15A Plant Nuclear Safety Operational Analysis (NSOA)

The information in this appendix of the reference ABWR DCD, including all subsections, tables, and figures, is incorporated by reference with the following departures.

Figure 15A-7 Safety System Auxiliaries—Group 2

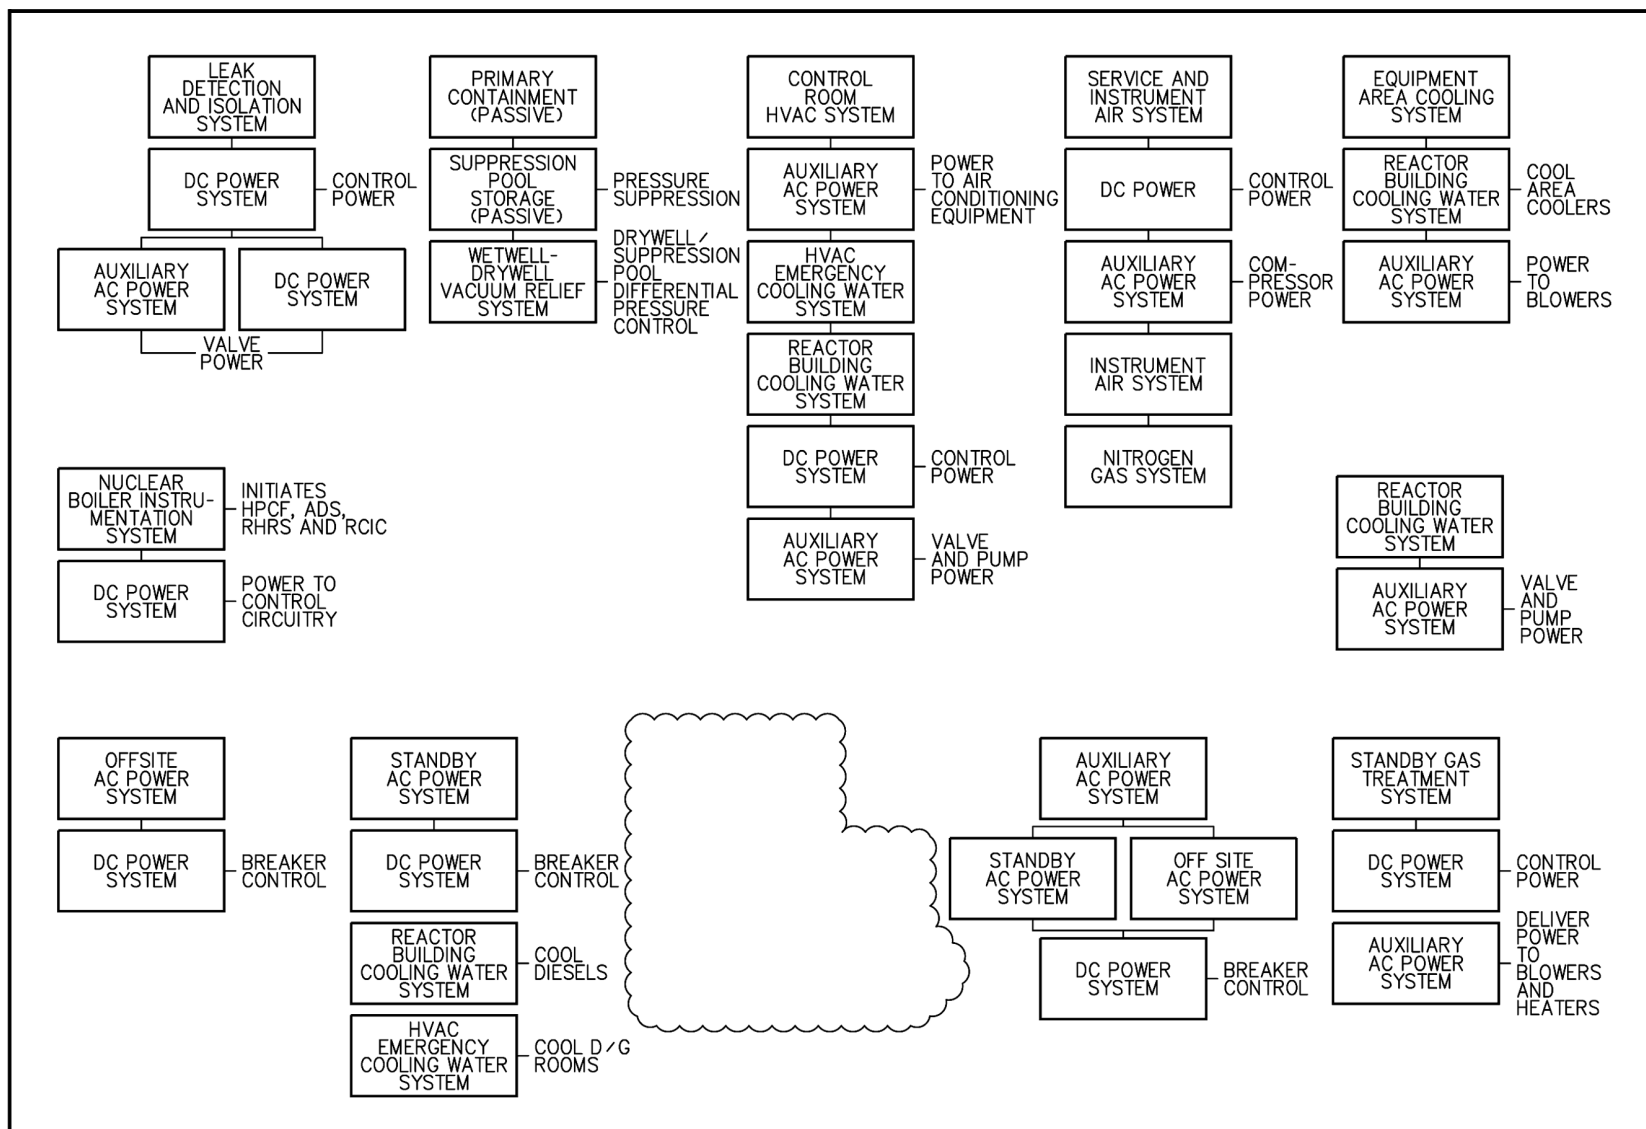
STD DEP T1 2.14-1 (Figure 15A-7)
